DEVELOPMENT APPLICATION ASSESSMENT REPORT

Application Number:	DA2020/0237
----------------------------	-------------

Responsible Officer:	Catriona Shirley
Land to be developed (Address):	Lot 130 DP 11162, 15 Alto Avenue SEAFORTH NSW 2092
Proposed Development:	Construction of a Dwelling House
Zoning:	Manly LEP2013 - Land zoned R2 Low Density Residential
Development Permissible:	Yes
Existing Use Rights:	No
Consent Authority:	Northern Beaches Council
Land and Environment Court Action:	No
Owner:	Shannon Elizabeth Deeran
Applicant:	Matthew Paul Deeran Shannon Elizabeth Deeran

Figure 1: Front setback variation shown in green.

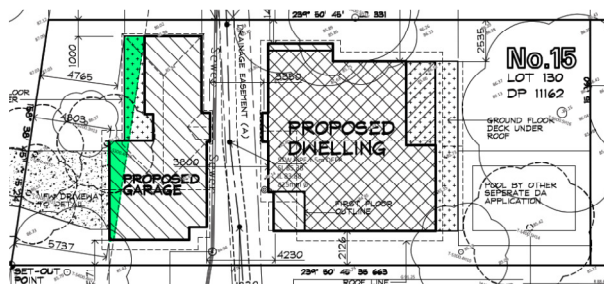
As demonstrated in figure 1 below, the front setback non-compliance occurs at the south-eastern and western corner of the garage structure and a minor portion of the decking area.

The proposed detached pavilion style Garage presents as a one storey structure from the street view, with the two storey dwelling house siting behind the detached pavilion style Garage. The stepping of the building heights into the site, along with the compliant Floor Space Ratio, landscaped area and sufficient built form modulation, provides a desirable outcome and compatibility with the existing character of the street and local area.

The landscape plans submitted with the stage one application, and additional conditional landscaping, ensure the front setback area between detached Garage and the front boundary will be densely landscaped such that the landscape character of the street will be preserved.
